Planning Commission Meeting Agenda  
December 15, 2020  
7:00 PM

- 2. THE MATTER OF THE BUTTERFLY GARDENS SITE PLAN REVIEW APPLICATION #LU 420-2020**

**THE MATTER OF THE BUTTERFLY GARDENS SITE PLAN REVIEW  
APPLICATION #LU 420-2020**

**CONCEPTUAL SITE PLAN FOR BUTTERFLY GARDEN MOBILE HOME PARK**  
CITY OF HARRISBURG

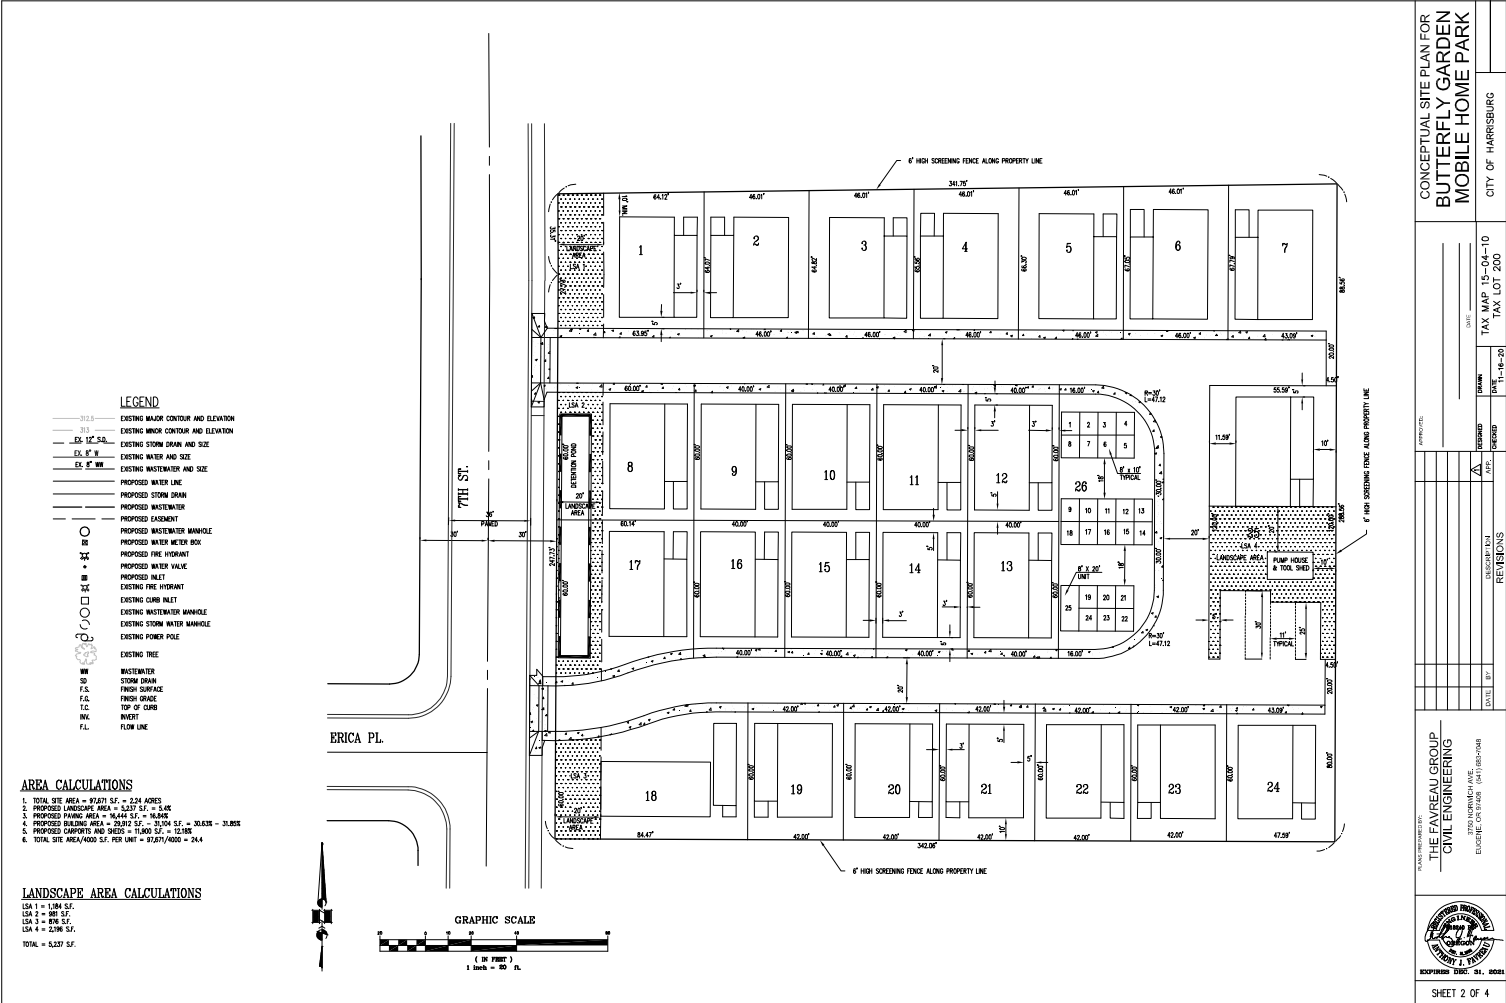
**Discussion:** All MDs as shown on site plan meet minimum 10’ separation criterion, 20’ criterion, and the two 5’ criterions. The 6’ separation from accessory buildings is less than 6’ compared to a MD on the same lot. Staff believes that this is acceptable. However, Lots 12 and 13 are less than 6’ from the storage units located in the center of the park.

**Street Lights:** The proposed development plan shall be revised to show the location of street lights on the interior private drive. Design and type of street lights will be approved by the Public Works Director.

**Mail box Clusters:** The proposed development plan shall be revised to show the location of mail box clusters. Type of mail boxes will be determined by the local postmaster.

- c. **Solid Waste Management:** The developer has not addressed solid waste management in their narrative; therefore, the developer must provide the City with a plan on how rubbish will be collected in the planned MD park. If a centralized location is proposed, then the proposed development plan shall be revised to show the location, as well as how it will be screened from view.

**Condition:** The developer will be required to submit a revised development plan that shows 6 feet of separation between the homes on lots 12 and 13 and the storage units. The storage unit size may be altered slightly, or moved to meet this requirement, or the developer will be required to provide a firewall in the construction of the storage units.

6. **Revised Plat** – Prior to the placement of the first home, the developer will be required to submit a revised development plan that shows 6 feet of separation between the homes on lots 12 and 13 and the storage units. The storage unit size may be altered slightly, or moved to meet this requirement, or the developer will be required to provide a firewall in the construction of the storage units.

- a. **Street Lights:** The proposed development plan shall be revised to show the location of street lights on the interior private drive. Design and type of street lights will be approved by the Public Works Director.

- b. **Mail box Clusters:** The proposed development plan shall be revised to show the location of mail box clusters. Type of mail boxes will be determined by the local postmaster.
